BRAKE DUST

HORIBA's input on the brake enclosure specification

13.02.2020; Yoshinori Otsuki, Dmytro Lugovyy, Joel Danzer

TF#24: Brake enclosure

General design considerations: Internal dimensions and shape of the enclosure

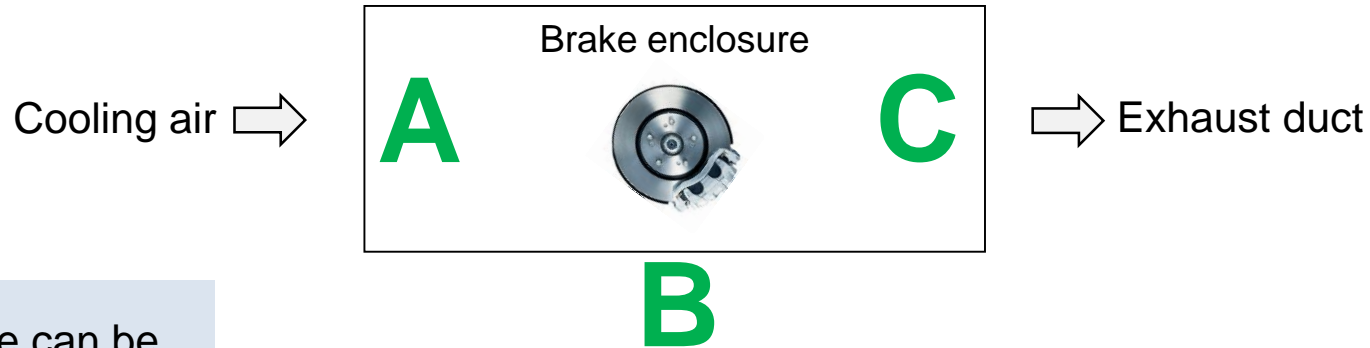
The brake enclosure can be separated into 3 areas:

- The cooling air supply section (A)
- The particle generation and collection area (B)
- The particle transport section (C)

The dimensions of these 3 areas are not constant and vary...

- between different tests (due to brake dimensions, cooling air flow rates...)
- different laboratories/ dynamometers (due to different duct dimensions, flow homogeneity...)
- even within a single test (due to brake rotation speed, local turbulences, particle characteristics...)

→ **Geometric requirements shall NOT be introduced as they are mainly determined by the operation conditions and the duct work! Simplified design restrictions do not consider the 3 variable sections within the enclosure!**
